WALKER FAMILY DIVISION SUBDIVISION

APPLICATION NUMBER 15 DATE June 19, 2008

REQUEST Subdivision

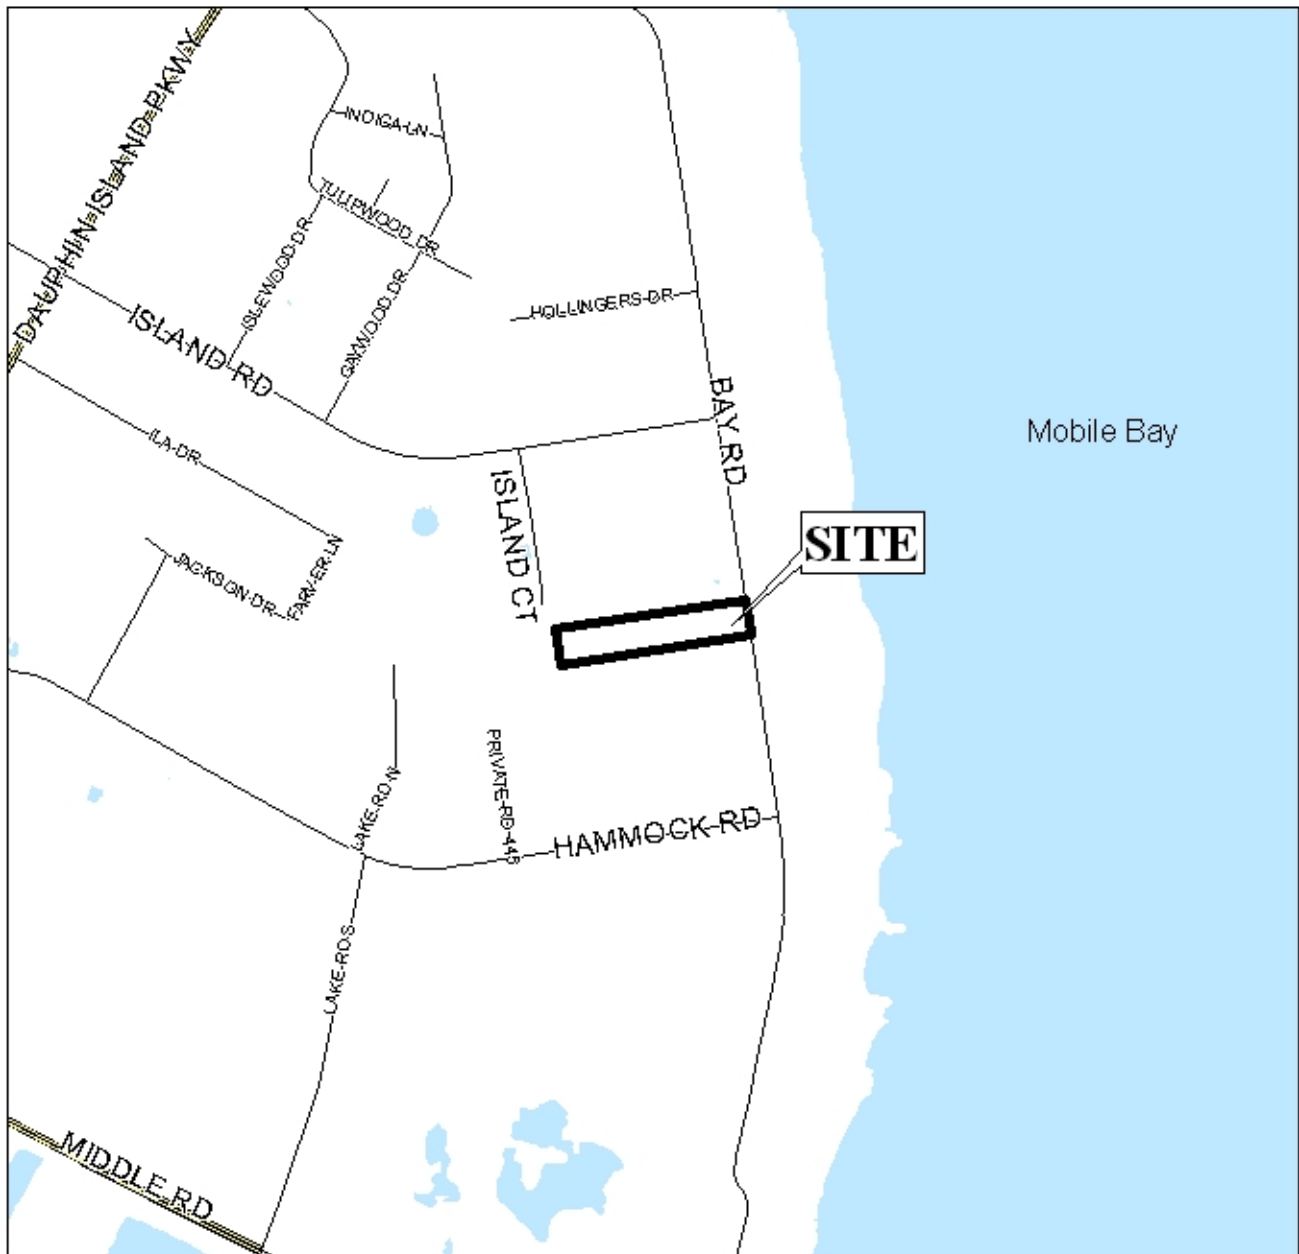
The plat illustrates the proposed 3 lot, 4.6± acre subdivision located on the West side of Bay Road, 1000'± North of Hammock Road. The applicant states that the subdivision is served by public water and sanitary services.

The site fronts on Bay Road, a minor street with adequate 60' right-of-way. As a means of access management, a note should be required on the final plat stating that each lot is limited to one curb cut to Bay Road, with the size, location and design to be approved by County Engineering and conform to AASHTO standards.

The plat indicates a 100' building setback line from Bay Road for Lots 1 and 2, and a 25' building setback line for Lot 3 from the rear of Lots 1 and 2. These setbacks should also be shown on the final plat. All lots are labeled with their sizes in square feet and acres, and the lots on the final plat should be so labeled, or a table should be furnished providing the same information.

According to Section V.D.3 of the Subdivision Regulations, the maximum depth of any lots shall not be more than 3.5 times the width of the lot at the building setback line. While the proposed lots will exceed this ratio, this is typical of the lots along Bay Road. Proposed Lot 3 will be a flag lot with only 25' of frontage on Bay Road. The April 2008 amendment to Section V.D.1. of the Subdivision Regulations generally does not allow the creation of panhandle or flag lots. While the creation of flag lots is discouraged, they are permitted only in those locations where varied and irregularly-shaped lot designs are common and the informality of design is consistent with other lots in the vicinity, or in the case of a family division. There have been other flag lots allowed by the Planning Commission on Hollinger's Island, particularly along Bay Road, and this particular subdivision qualifies as a family division among three brothers. A waiver of Sections V.D.1. and V.D.3. of the Subdivision Regulations would be required and a note should also be placed on the final plat stating that no further resubdivision of Lot 3 is allowed until additional frontage on a public street is provided.

While the site is in Mobile County, it will have to comply with the City of Mobile storm water and flood control ordinances. A note should be placed on the final plat stating that the development will be designed to comply with the storm water detention and drainage facility requirements of the City of Mobile storm water and flood control ordinances, and requiring

submission of certification from a licensed engineer certifying that the design complies with the storm water detention and drainage facility requirements of the City of Mobile storm water and flood control ordinances prior to the issuance of any permits. Certification is to be submitted to the Planning Section of Urban Development and County Engineering.

With a waiver of Section V.D.3., the proposed plat meets the minimum requirements of the Subdivision Regulations and is recommended for tentative approval subject to the following conditions:

- 1) Placement of a note on the final plat stating that each lot is limited to one curb cut to Bay Road, with the size, location and design to be approved by County Engineering and conform to AASHTO standards;

- 2) illustration of the minimum building setback lines on the final plat, with the setback for Lot 3 measured from the rear lines of Lots 1 and 2;
- 3) labeling of each lot with its size in square feet and acres, or the furnishing of a table on the final plat providing the same information;

- 4) placement of a note on the final plat stating that no further resubdivision of Lot 3 is allowed until additional frontage on a public street is provided;

- 5) placement of a note on the final plat stating that the development will be designed to comply with the storm water detention and drainage facility requirements of the City of Mobile storm water and flood control ordinances, and requiring submission of certification from a licensed engineer certifying that the design complies with the storm water detention and drainage facility requirements of the City of Mobile storm water and flood control ordinances prior to the issuance of any permits. Certification is to be submitted to the Planning Section of Urban Development and County Engineering;
